Access Compliance Report

Public Rights-of-Way

Intersection ID: 24214	Main Street: HENSEY'S_WY	Cross Street: BEVERLY_CREST_BV	Location:	N
ADA ID: 2EBF2BB2784F	Ramp Type: Perp	Initial Pass/Fail: Fail	Overall Compliance: No	Severity Score: 12.5

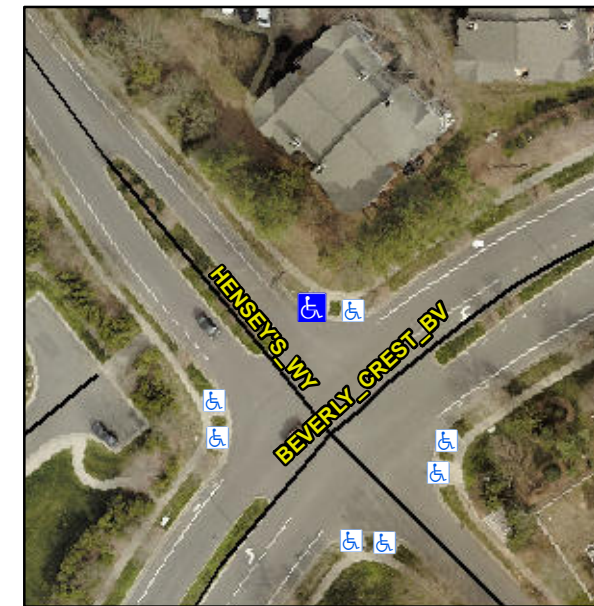
Not Found, R304.2.2

Compliance	Description	Data	Compliance	Description	Data
N/A	Ramp Length (in)	107.0	No	Ramp Slope (%)	8.8
Yes	Ramp Width (in)	91.0	Yes	Ramp XSlope (%)	0.2
N/A	Flare Type LT	N/A	N/A	Flare Type RT	N/A
N/A	Flare Slope LT (%)	N/A	N/A	Flare Slope RT (%)	N/A
N/A	Flare Traversable LT?	N/A	N/A	Flare Traversable RT?	N/A
N/A	Landing Length (in)	N/A	N/A	DWS Provided?	N/A
N/A	Landing Width (in)	N/A	N/A	DWS Contrast?	N/A
N/A	Landing Slope (%)	N/A	N/A	DWS Length (in)	N/A
N/A	Landing X Slope (%)	N/A	N/A	DWS Full Width?	N/A
N/A	Landing Curb? (Y/N)	N/A	N/A	DWS Offset (in)	N/A
N/A	Shared Landing?	N/A			
N/A	Gutter Ponding?	N/A	N/A	Gutter Slope (%)	N/A
N/A	Gutter Lip Ht (in)	N/A	N/A	Gutter X Slope (%)	N/A
N/A	Painted X Walk1?	No	N/A	Painted X Walk2?	N/A
	X Walk 1 Direction	To SW		X Walk 2 Direction	N/A
N/A	X Walk 1 Width (in)	N/A	N/A	X Walk 2 Width (in)	N/A
	X Walk 1 Slope (%)	2.2		X Walk 2 Slope (%)	N/A
	X Walk 1 X Slope (%)	0.3		X Walk 2 X Slope (%)	N/A

Remove & Replace Entire Ramp.
